**LINCOLN PARK PLANNING COMMISSION**  
CITY HALL – COUNCIL CHAMBERS  
1355 SOUTHFIELD ROAD  
LINCOLN PARK, MICHIGAN

City of Lincoln Park,  
Wayne County, Michigan  
**SITE PLAN DOCUMENTS**  
Prepared For  
White Castle Systems

Project Name  
**White Castle - DE #15**  
**2115 Fort Street**

White Castle, 2115 Fort Street  
**Site Plan Review**

SHEET  
Landscape Plan

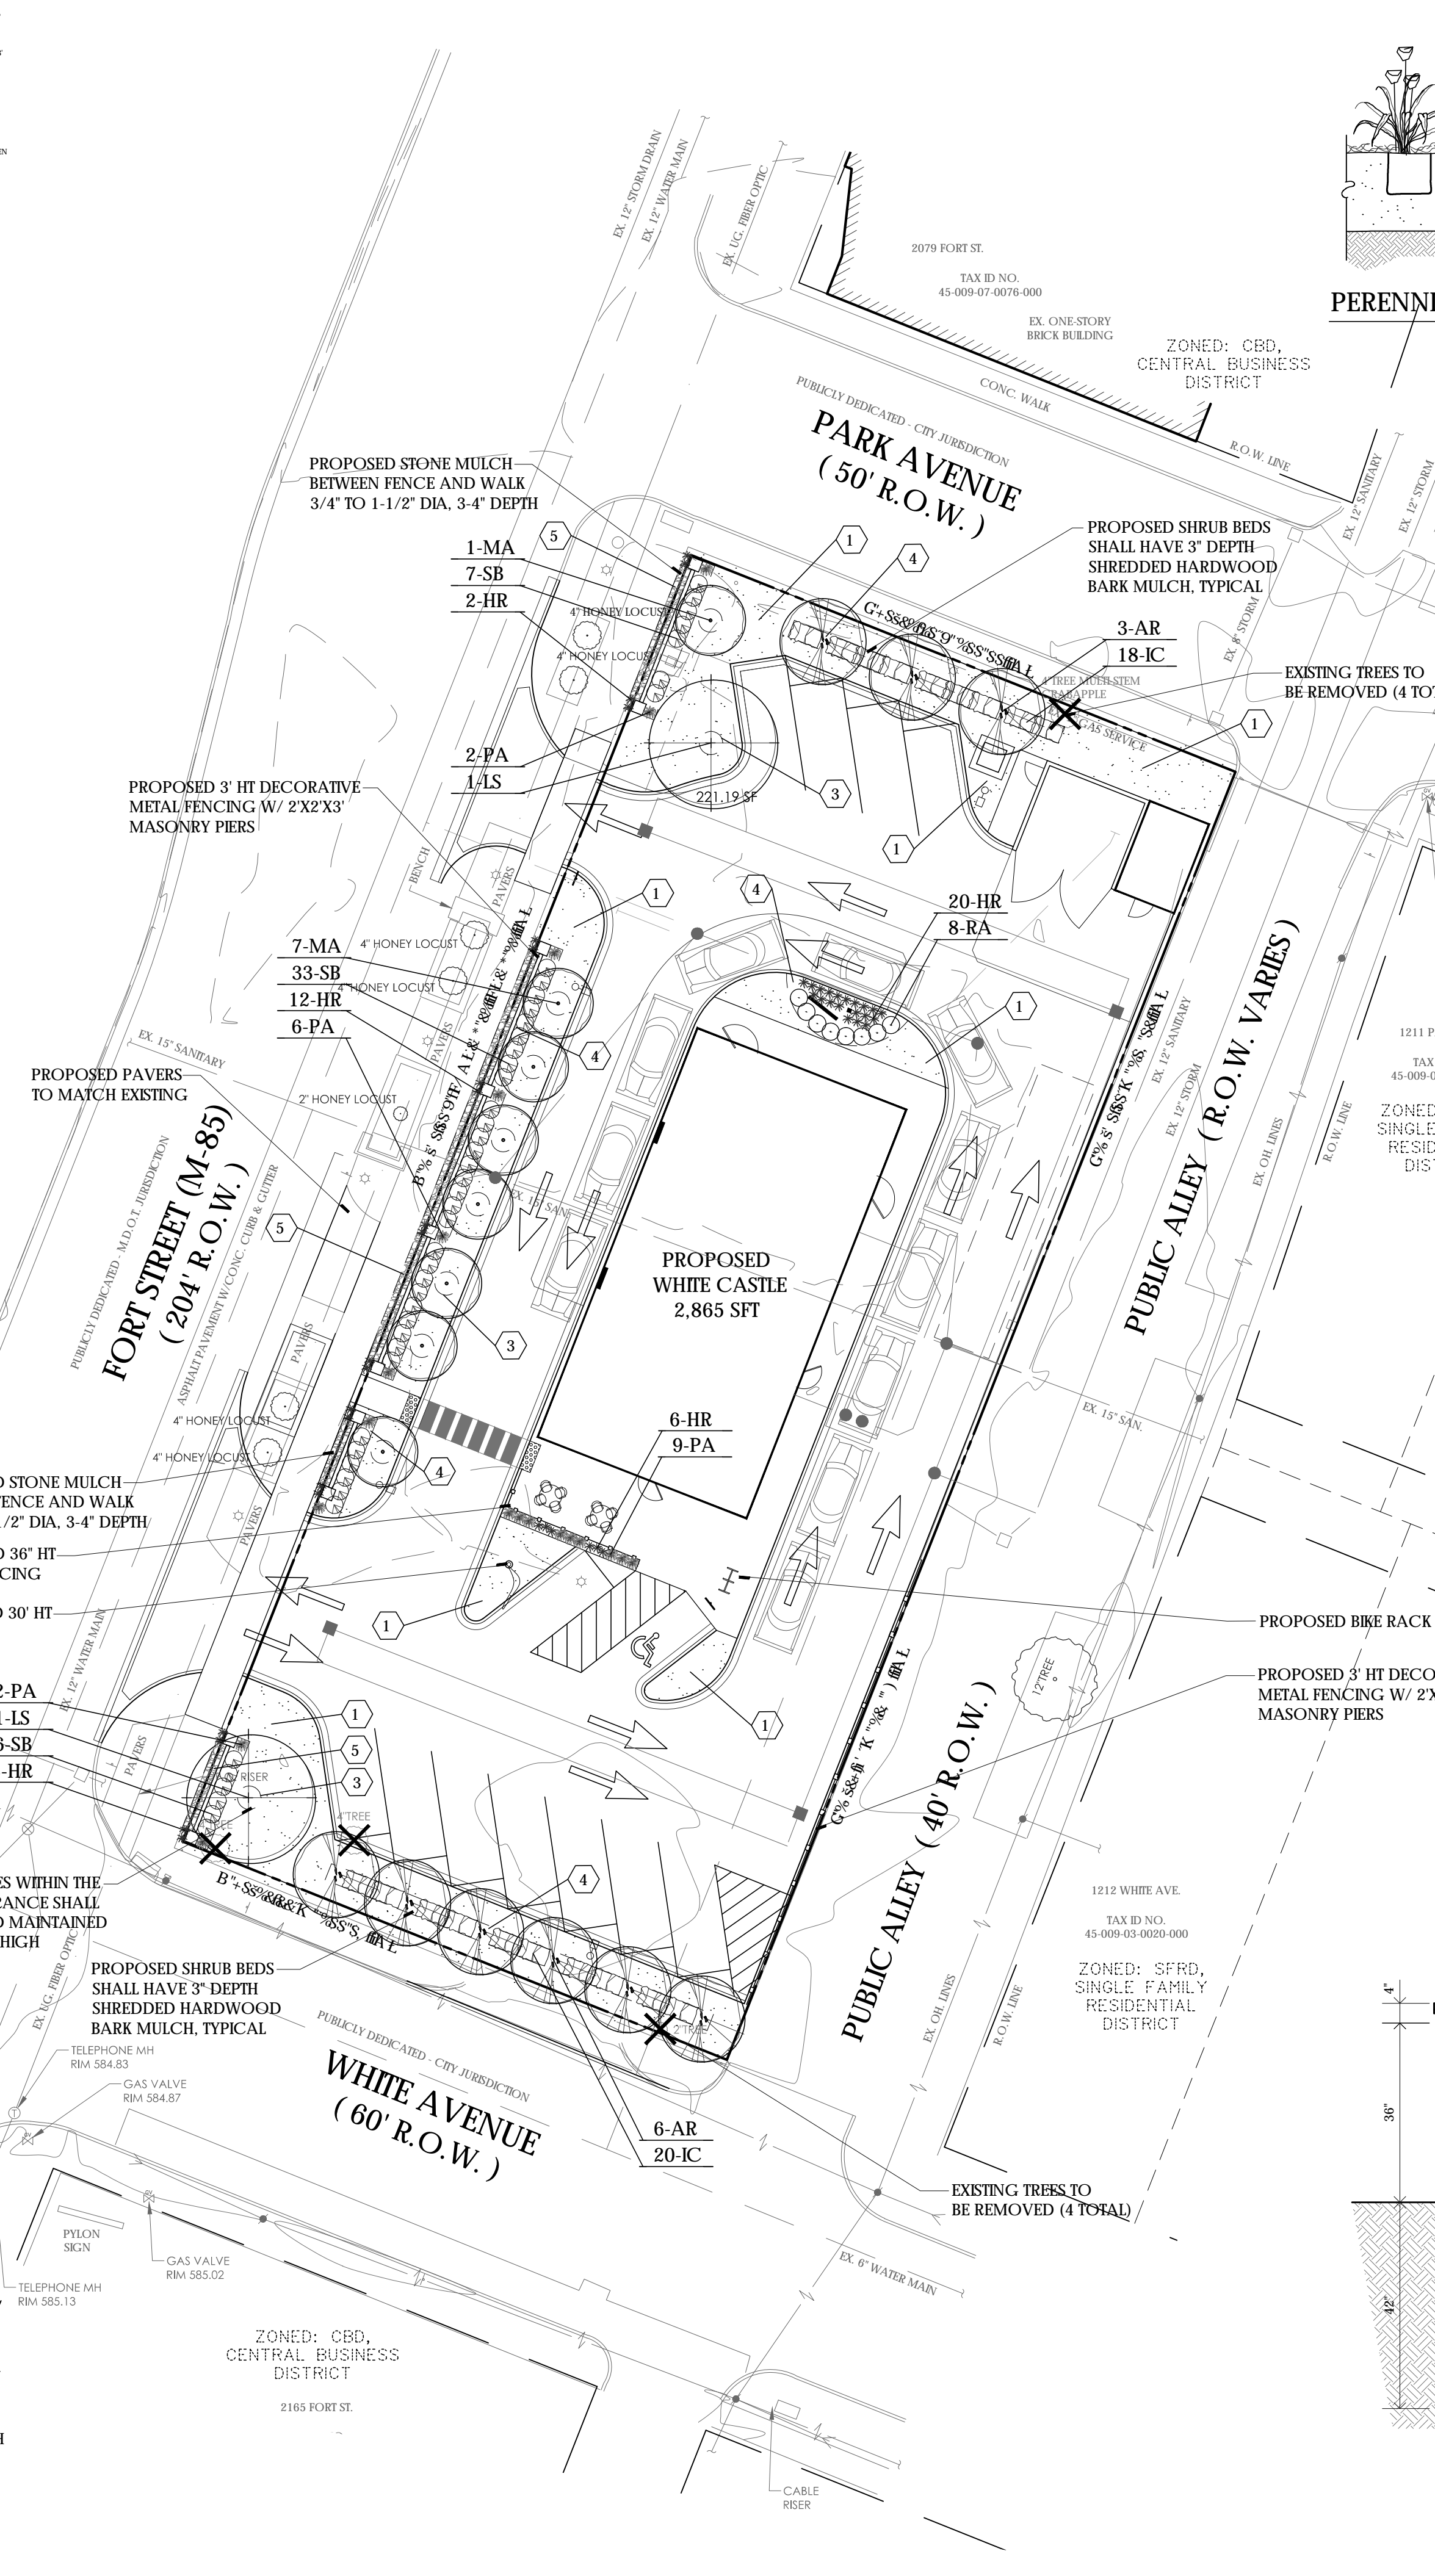
**Foundation plantings are not shown.**

- Landscaping is recommended in the outdoor patio area.*
- Planning Commission to accept proposed combination of trees, shrubs, flowers, and ornamental grass to meet CBD landscaping standards*

- Foundation plantings to be added where practical
- Landscaping is recommended in the outdoor patio area.
- Planning Commission to accept proposed combination of trees, shrubs, flowers, and ornamental grass to meet CBD landscaping standards

### XLCL LED Area Light

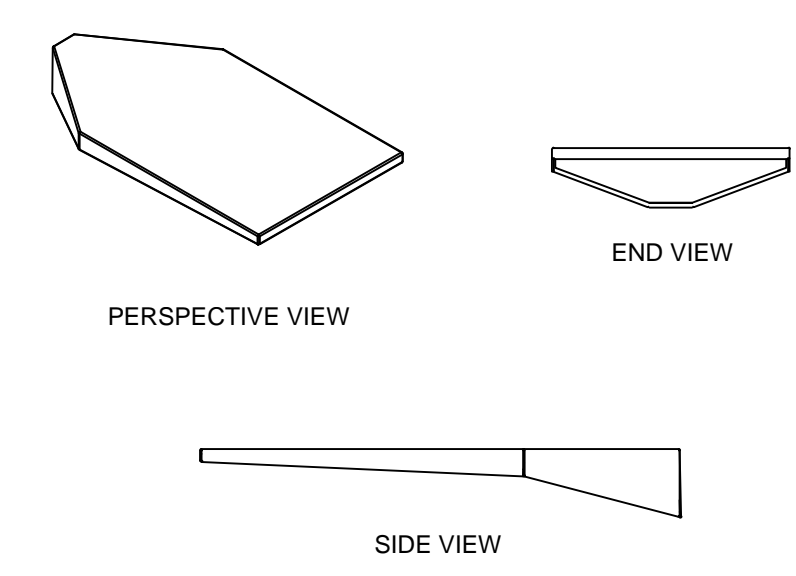
The applicant proposes ten (10) exterior lights attached to the building, and four (4) pole lights in the parking areas. Pole lights are down-directed and meet the stated conditions. **Wall lights do not appear to be shielded; detail is required.**

- Applicant to provide wall light detail documenting compliance with shielding and other regulations*

- Applicant to provide wall light detail documenting compliance with shielding and other regulations
